Texas Commission on Environmental Quality

Title V Existing

Site Information (Regulated Entity)

From:	Emily Knodell
Sent:	Wednesday, July 24, 2024 1:59 PM
То:	Li, Jing
Subject:	RE: Working Draft Permit FOP O4075/Project 35851, Enterprise Products
	Operating LLC/Orla Gas Plant

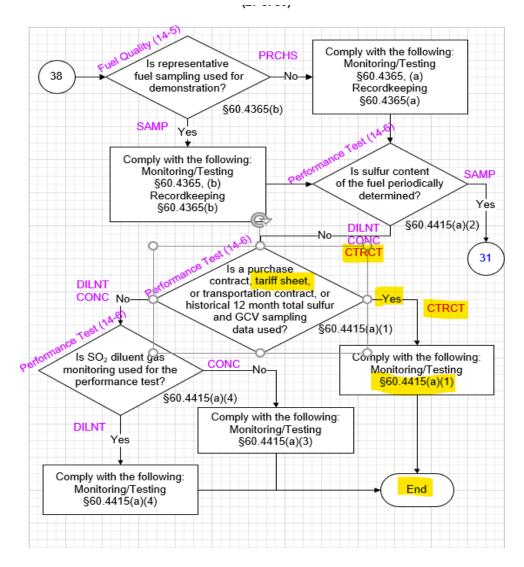
GRPTURBINE: KKKK monitoring for sulfur has been changed from 60.4415(a)(1) and 60.4415(a)(1)(ii) in existing permit to 60.4415(a)(2) and 60.4415(a)(2)(ii); I don't agree with this change as since we use tariff sheet for sulfur (60.4365(a) for recordkeeping), we should get 60.4415(a)(1) and 60.4415(a)(1)(ii) for monitoring. Please let me know if I need to update the attribute form.

This will require an updated OP-UA11. The "Performance Test" question will need to have an updated code to "CTRCT" in order to pick up the 60.4415(a)(1) requirement. 60.4415(a)(1)(ii) no longer exists in the CFR. What we currently have in our database is "SAMP" code. See my highlights in flowchart below. Please see attached.
